Planning Decisions Committee

6.30pm, Tuesday 31 January 2023

1. This report provides Council with an assessment of Planning Application PLN21/0569 which is for partial demolition, alterations and construction of a multi storey building for an office and two dwellings (no permit required for the uses) and a reduction in the statutory car parking requirement of the Yarra Planning Scheme. The report recommends a position of approval subject to conditions.

Ward:	Langridge
Proposal:	Partial demolition, alterations, construction of a multi storey building and a reduction in the statutory car parking requirement of the Yarra Planning Scheme
Existing use:	Shop
Applicant:	Context Design Group
Zoning / Overlays:	Commercial 1 Zone (C1Z) Design and Development Overlay (Schedules 30) Development Contribution Plan Overlay (Schedule 1) Heritage Overlay – Schedule 464 (HO464)
Date of Application:	6 August 2021
Application Number:	PLN21/0569

Figure 19: Heritage sightline

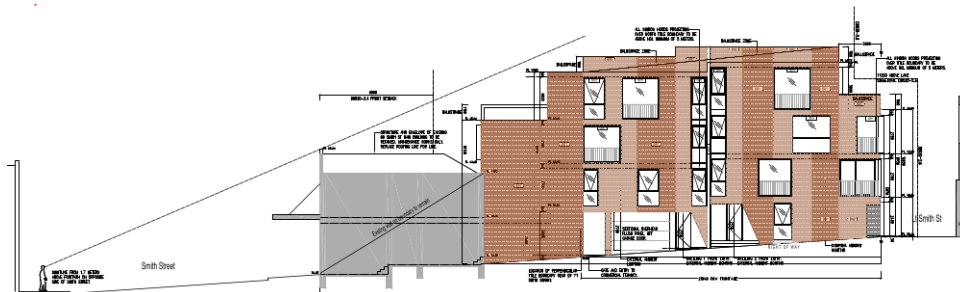
212. The following sightline provided by the applicant shows the 11.63m front setback of the addition is sufficient to obscure views of it from the opposite side of Smith Street:

213. The combination of the minimum 11.63m setback of the addition and the presence of a row of 3 double storey buildings between the subject site and the intersection with Gertrude Street (see figure 20) is adequate to ensure the addition is obscured on northern oblique views, in compliance with this requirement.

Figure 21: Western balconies of No's 40, 42 and 44 Little Smith Street

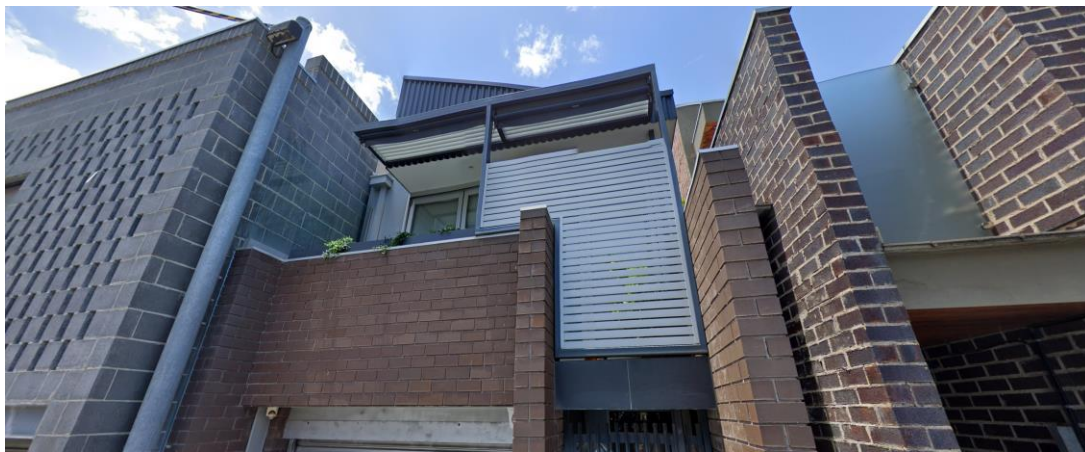
220. The proposal achieves partial compliance when considering overshadowing impacts to the first floor upwards for Little Smith Street properties to the south of the subject site.
221. Between 10am and noon, the west-facing first floor balconies of No's 40, 42 and 44 Little Smith Street have the potential to be overshadowed by the proposal. With shadows after this time limited generally to their roofs and not affecting their west-facing first floor open space. Their west-facing windows will be shadowed by their own walls between 10am and noon and with additional shadow as a result of the proposal having moved away from these windows by noon. Further detail is provided below.

Above: Sight line drawing extract from drawing no. TP301

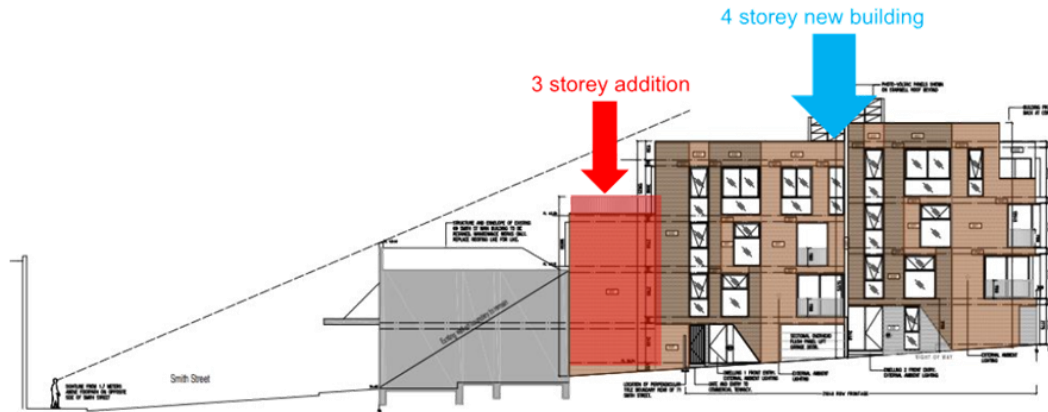
Based on the submitted sightline drawing it appears that the proposed four-storey building at the rear of the subject site will not be visible from Smith Street.

Above: Rear elevation of the proposed development fronting Little Smith Street

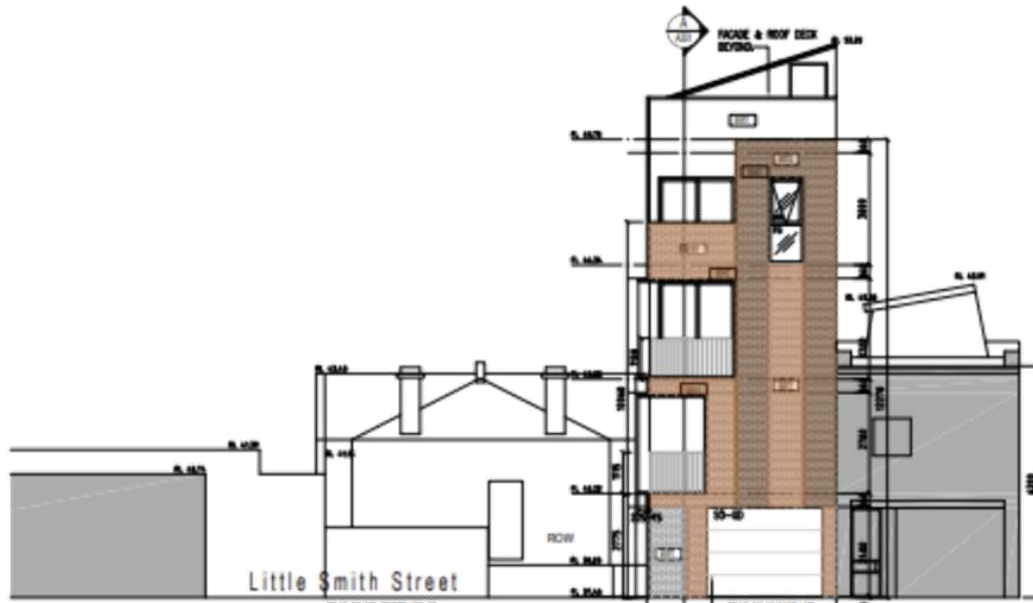
The scale of a four-storey street wall to Little Smith Street will however be at least one floor higher than the height of existing adjacent buildings in this part of the street. Setting the top floor back from the rear street frontage (west elevation) will bring the street wall height down to a similar height of other buildings in the street and therefore reduce the dramatic impact of this building, which will continue to be the highest in the area.

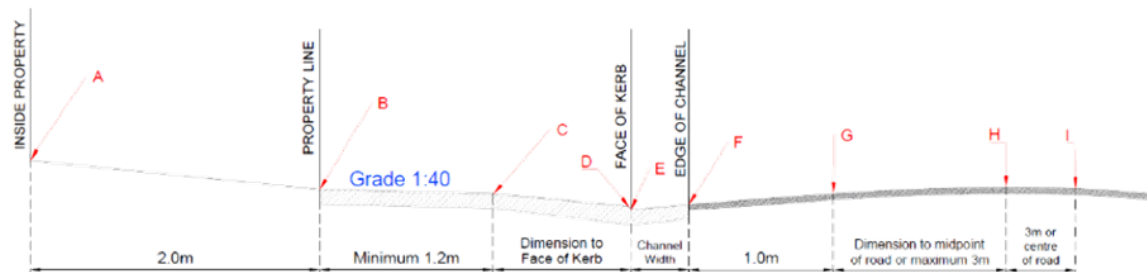
- o The designer must demonstrate that an 85th or 99th percentile vehicle profile can traverse the design cross section as per the Australian/New Zealand Standard ground clearance template (AS/NZS 2890.1:2004).

- o Significant level changes to the existing footpath level B to C will require additional level design either side of the proposed crossing.
 - o Please include any additional levels or changes in grade that are not shown in the diagram.
